Our Case Number: ABP-316272-23

Re: Bus Connects Templeogue/Rathfarnham to City Centre Core Bus Corridor Scheme
Templeogue/Rathfarnham to City Centre

Observations in relation to TEMPLEOGUE / RATHFARNHAM TO CITY CENTRE CORE BUS CORRIDOR SCHEME – Focus Rathmines Road Lower and adjoining area

How it works

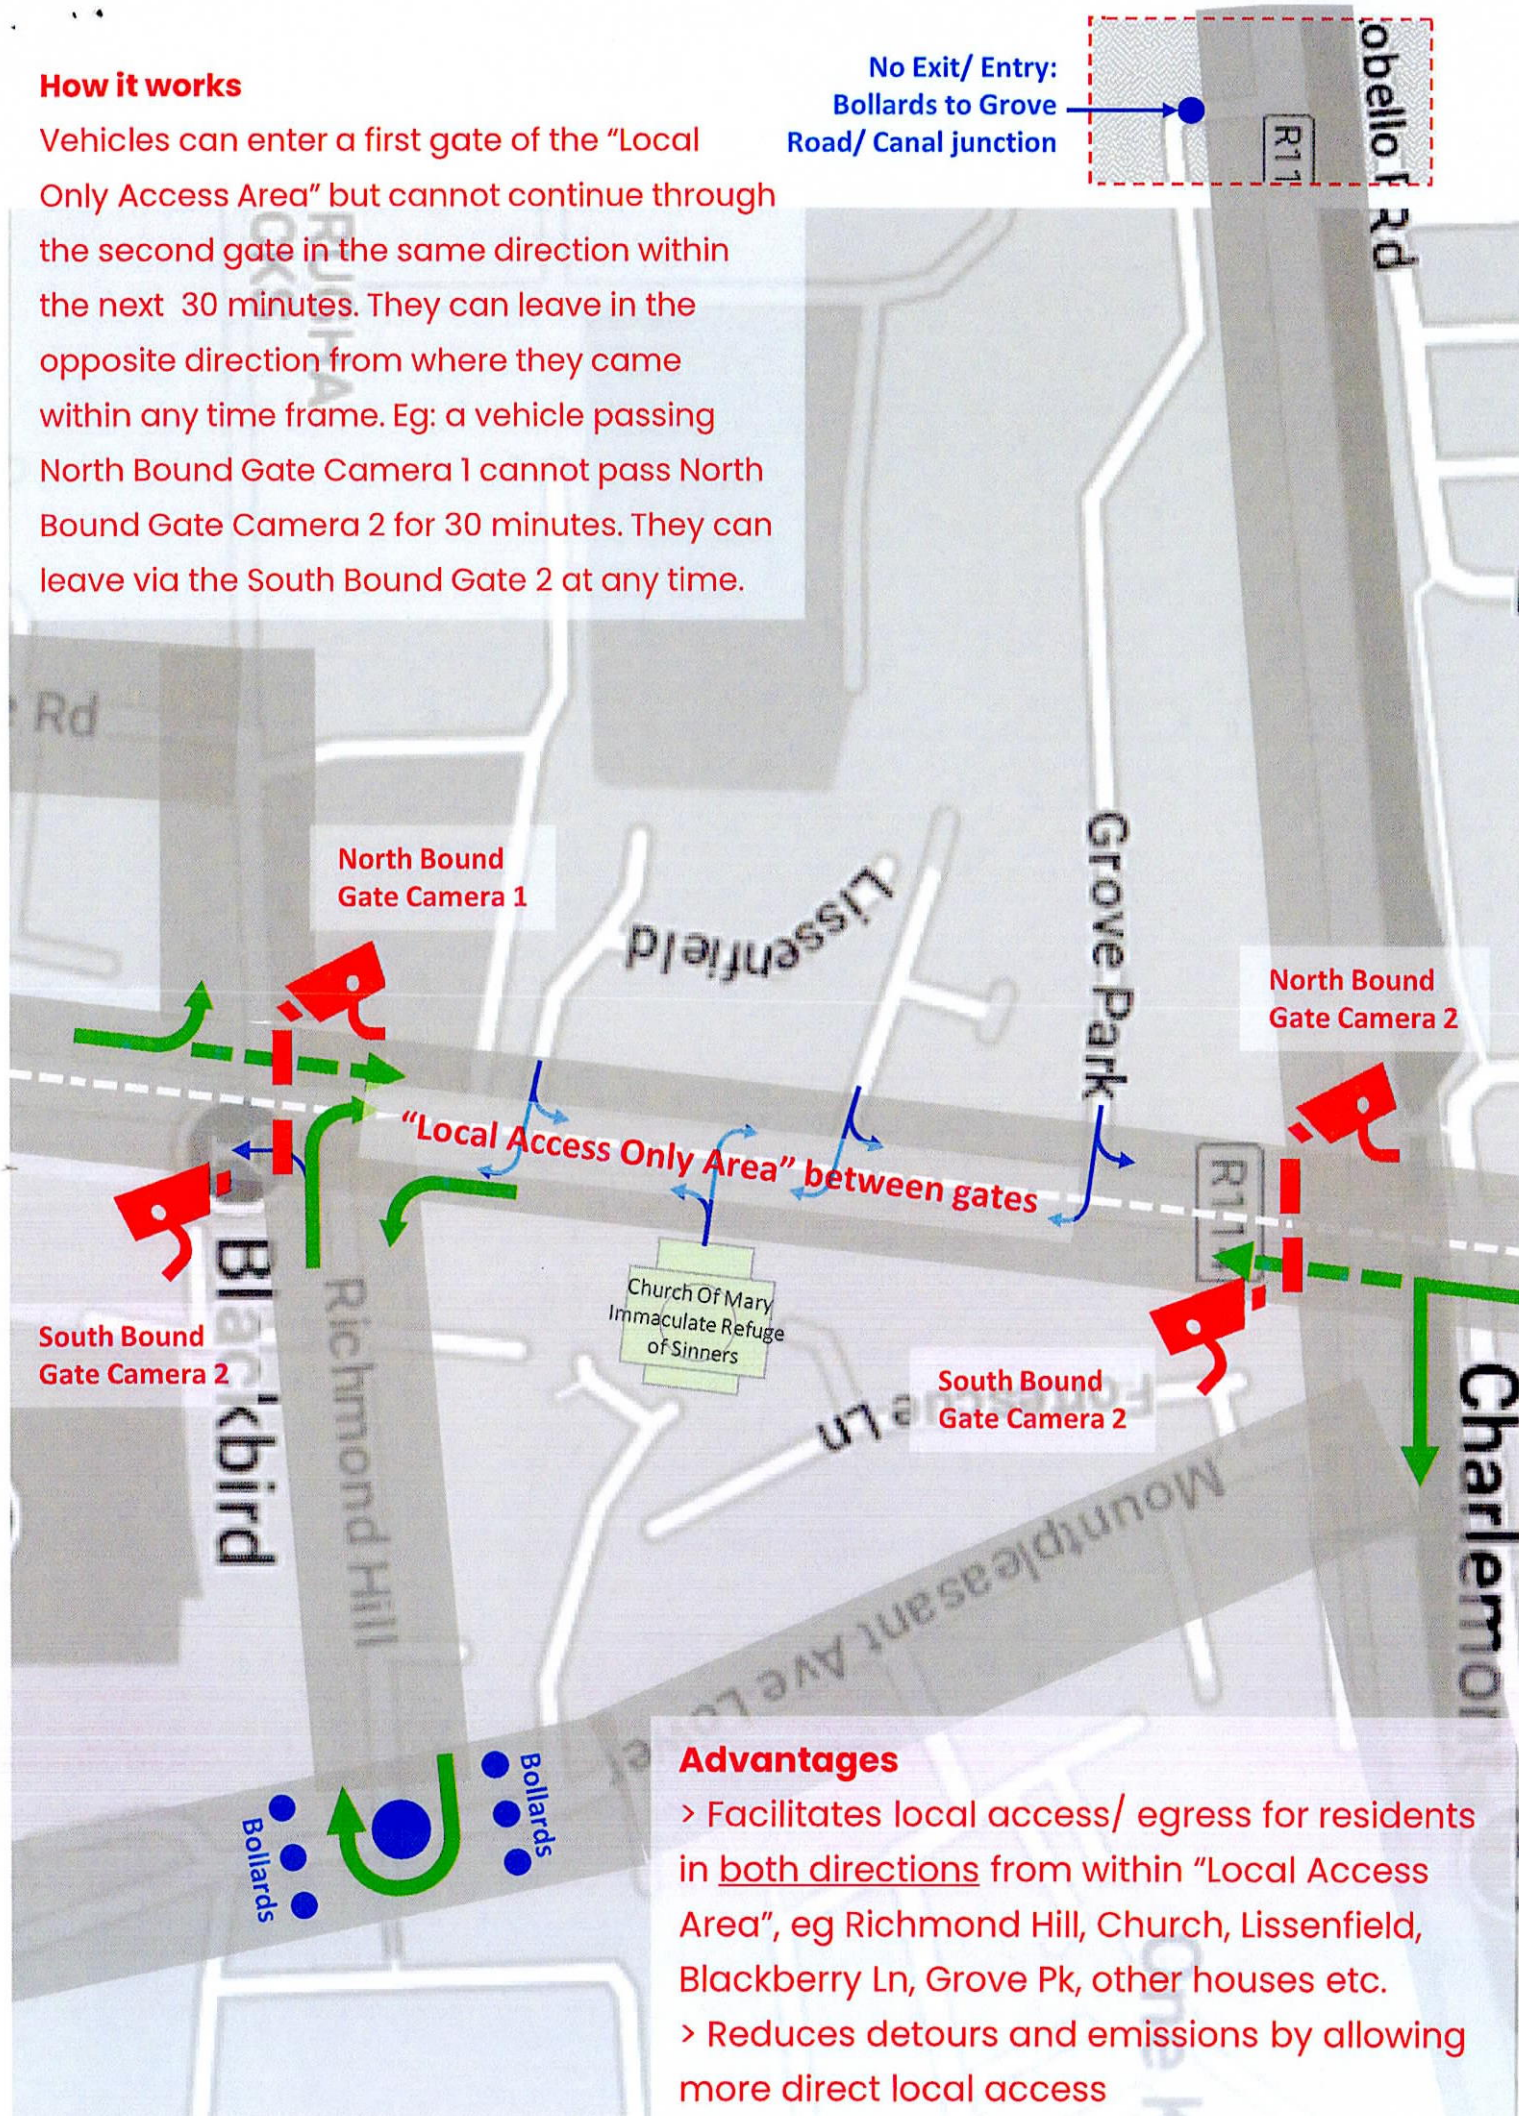
I would strongly suggest the introduction of a system that allows local access by making the area between Military Road and the Canal 'local access' only and introduce an automated system based on the technology that is used by toll roads.

By extending this local access area as far south as Military Road would mean Richmond Hill (where the Meals on Wheels operation for the area is located) could also be accessed from both directions on Rathmines Road. There would not be a Bus Gate in a single location as it currently proposed. Instead at the entrance to the 'local access area' signage would alert divers that this is a local access area only and that they can't pass the second virtual gate further along the road.

The local access area should extend from Military Road to Grove Road, which will require blocking off Mountpleasant Avenue Lower, Upper and Grove Park to avoid rat runs, but access to this area is still provided from both north and south direction. Anyone requiring access to the area between Military Road and the Canal will be able to access and exit the area from both directions. Only through traffic is not allowed. This would solve the issue with the access to businesses such as the Music School on Grove Park, access to the church and the facilitate the Meals on Wheels delivery service located on Richmond Hill.

A schematic of how this might work is attached.

Vehicles can enter a first gate of the "Local Only Access Area" but cannot continue through the second gate in the same direction within the next 30 minutes. They can leave in the opposite direction from where they came within any time frame. Eg: a vehicle passing North Bound Gate Camera 1 cannot pass North Bound Gate Camera 2 for 30 minutes. They can leave via the South Bound Gate 2 at any time.

No Exit/ Entry:
Bollards to Grove
Road/ Canal junction

- > Facilitates local access/ egress for residents in both directions from within "Local Access Area", eg Richmond Hill, Church, Lissenfield, Blackberry Ln, Grove Pk, other houses etc.
- > Reduces detours and emissions by allowing more direct local access

I request that An Bord Pleanála consideration of alternative solutions, such as the one suggested, that would ensure a clear route for buses whilst providing more direct local access and reducing detours for private vehicles, a condition of the planning approval.
